# Imray Correction Notice

ICA28-2

## Chart A28 WGS 84

Edition 2017

**22 Pointe-à-Pitre (Plan E)**

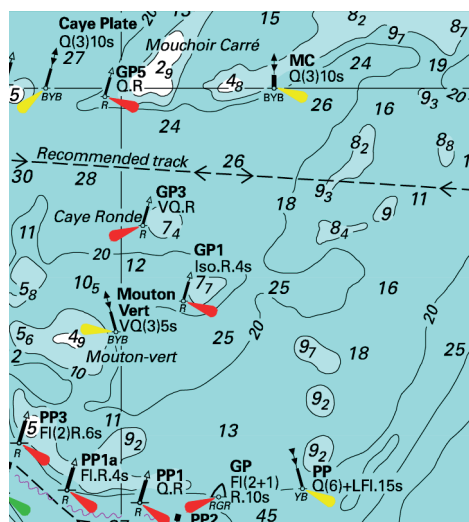
Amend light at Lt buoy **PJ3** Fl.G.2·5s to Fl.R.2·5s in 16°14'·13N 61°32'·61W

Amend Obstn depth 5.9m to 5m in 16°14'·19N 61°32'·60W

Add depth 0.4m to Obstn in 16°14'·30N 61°32'·75W

Insert Obstn depth 3.1m in 16°13'·78N 61°32'·07W

Delete drying wreck -0.8m in 16°14'·25N 61°32'·77W

Recent survey has shown that depths in this area may differ to that charted. Navigate with caution. (ILNW 25/25)
